## TECHNICAL MEMORANDUM

**Subject:** **Review of the Center Left Turn Lane Option for Watertown Plank Road  
Elm Grove, WI**

# Two-Way Left Turn Lane

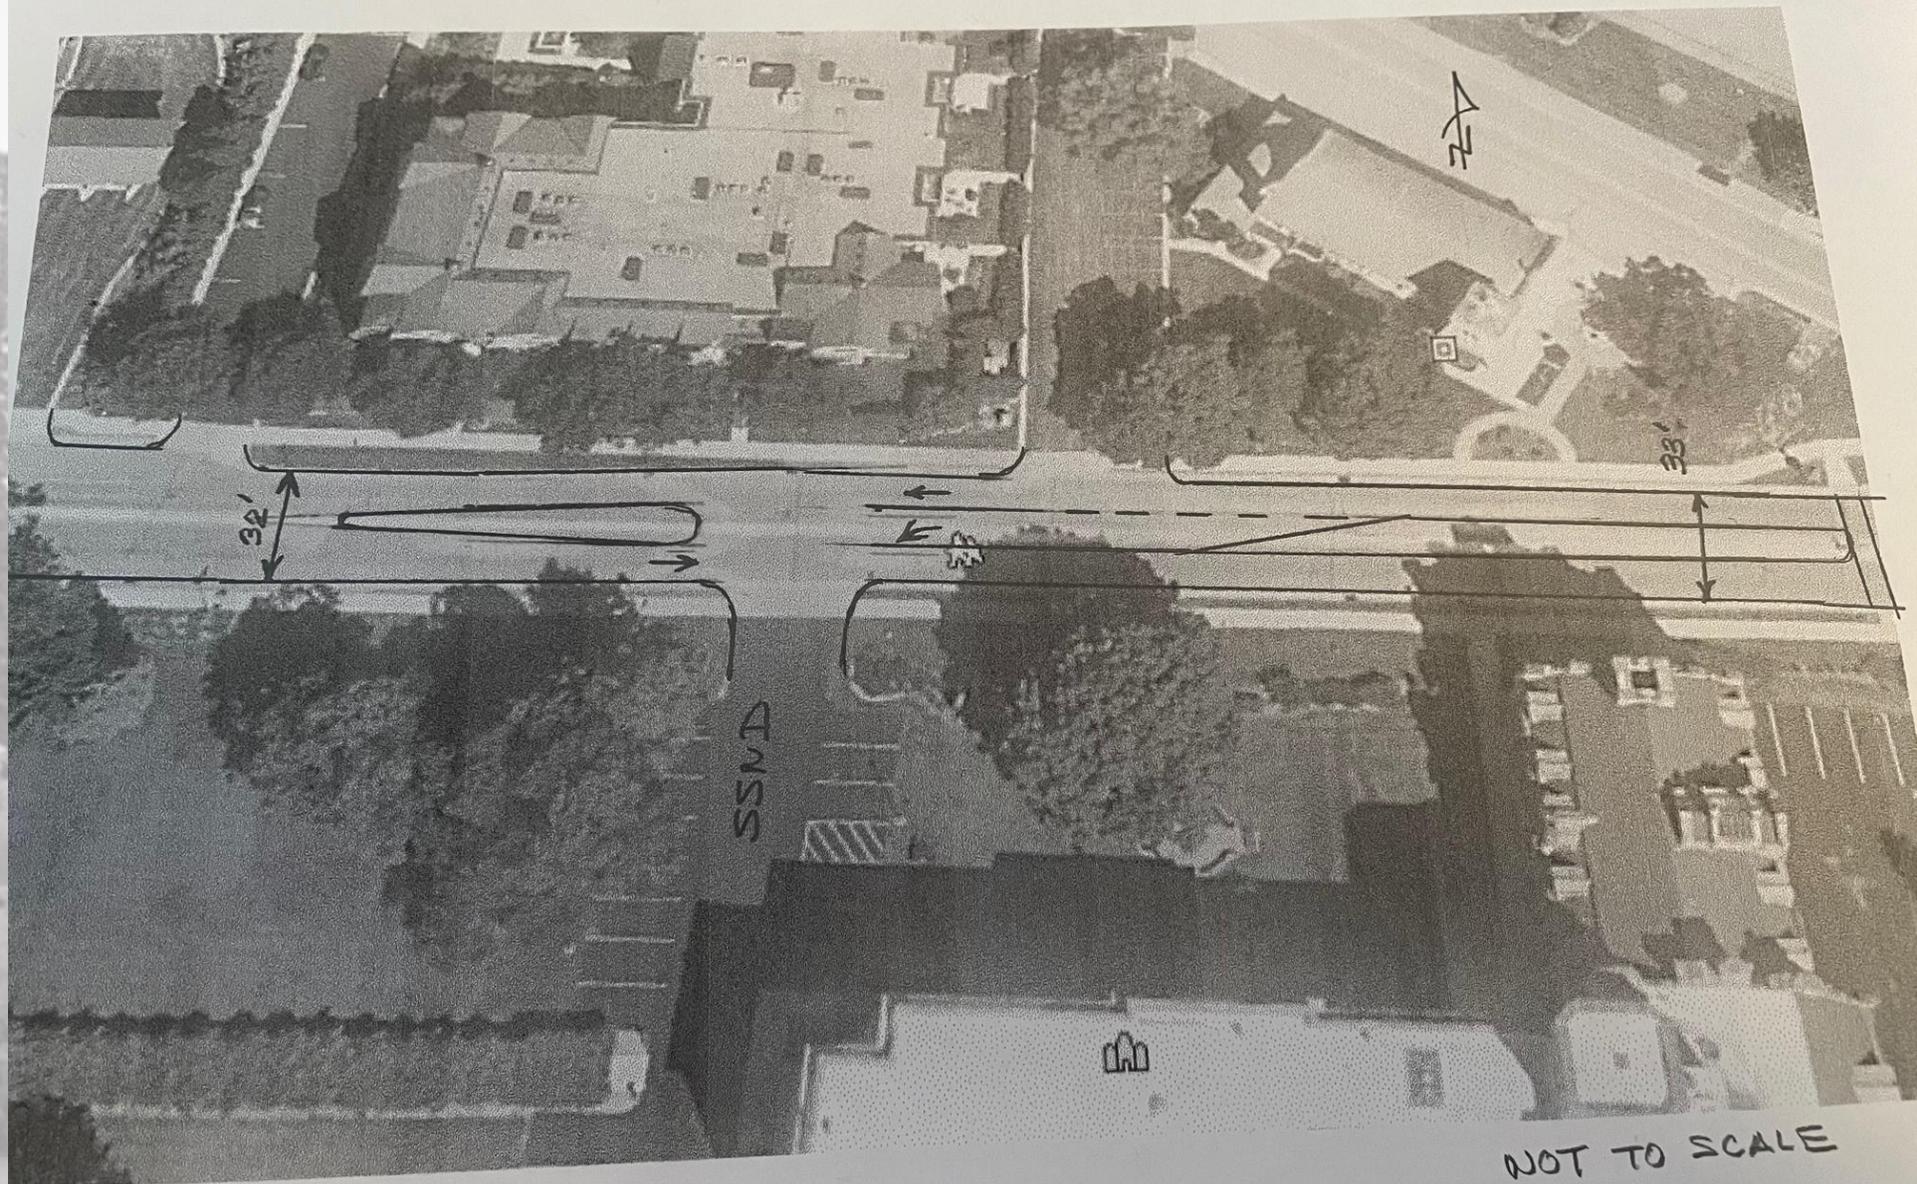
Properly designed left turn lanes along roadways typically provide for improved traffic operation and safety since slowing and stopped left-turn movements are removed from the through lane traffic flow. For the two-way left turn lane option shown for Watertown Plank Road, however, the additional lane is not expected to result in a benefit to either operations or safety to the roadway system due to the following:

- Based on the evaluation of the Watertown Plank Road intersections with the SSND east driveway, Juneau Boulevard, and Crescent Drive with the additional traffic volumes from the proposed SSND redevelopment, acceptable traffic operations are expected during the peak hours with the existing two-lane cross-section (no left turn lanes) along Watertown Plank Road. Even with the redevelopment of the SSND site, left turn volumes at the SSND east driveway, Juneau Boulevard, and Crescent Drive are expected to be relatively low during the peak hours. In summary, the low number of left turning volumes do not justify the need for separate left turn lanes.
- Based on a review of the crash history for Watertown Plank Road, no crash patterns emerged related to left-turn movements in the existing shared through/left-turn

lanes. The crash history does not support the need for separate left turn lanes through this area.

- Adding in a center lane on Watertown Plank Road would result in narrowed lanes of only 11 feet. A typical center two-way left turn lane in an urban area is typically 14 to 16 feet wide. In this case, the middle left turn lane would only be 11 feet wide, which causes concern for left turning operations. As lane width is a factor in lane capacity, the narrowed lanes could result in reduced capacity through the roadway segment with the center left turn lane.

- The driveway to Watertown Plank Road for the office building just north of the SSND building is offset from the SSND east driveway, resulting in only about 40 feet of storage for left turns if a two-way center left turn lane were striped on Watertown Plank Road. This spacing is inadequate to simultaneously store both a westbound left turn vehicle at the SSND east driveway and an eastbound left turn vehicle at the office driveway. The spacing may also result in safety issues as left turn vehicles for both driveways attempt to enter/drive-through the same space.

- The transition taper between the through lanes in the segment with the center left turn lane to the through lanes in the existing two-lane cross-section on Watertown Plank Road is substandard and is considered inadequate for the design speed of the roadway.

Based on the factors listed above, it is not recommended to restripe Watertown Plank Road between the SSND east driveway and Crescent Drive with a center left-turn lane.
